Subject: **License SUA-1473, Docket 40-8905  
Pond 2 Cell Design Plan Revision**

## **Pond 2 Cell Design Plan Revisions**

## **ADDITIONS/CHANGES TO REVISION 1 RECLAMATION PLAN TAILINGS CELL 2, Dated May 2007**

FIGURE 7.2

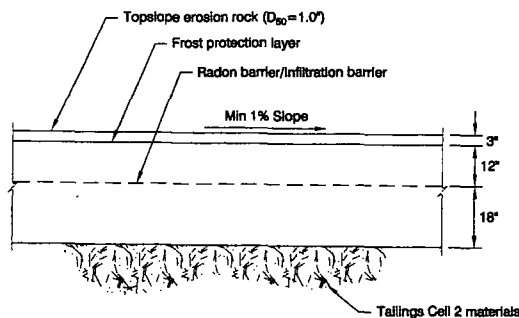
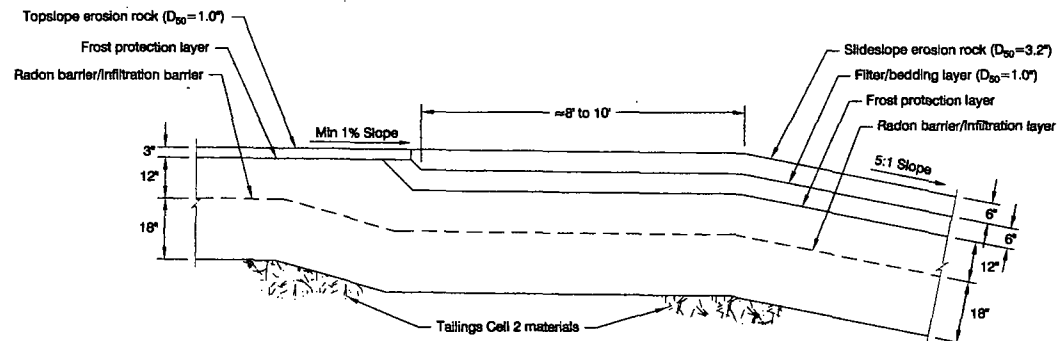
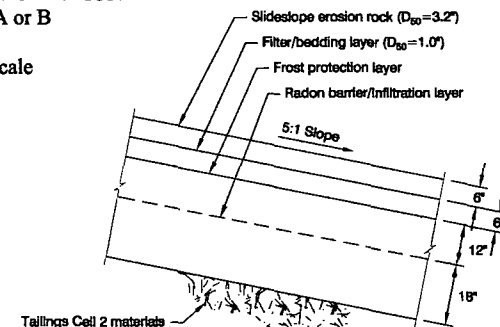
Revised drawings are included with this submittal. Revisions consisted of correcting a typographical error on 7.2 and removing the gradation tables from the drawings.

2. The erosion protection for the topslope of Pond 2 shall be constructed of a rock diameter  $d_{50}=1.0''$  conforming to the gradation as presented on Table 7.4.

3. The slideslope erosion protection of Pond 2 shall be constructed of a rock diameter  $D_{50}=3.2''$  and shall be placed on a minimum 6" thick filter/bedding layer, and conform to the gradation as presented on Table 7.4.
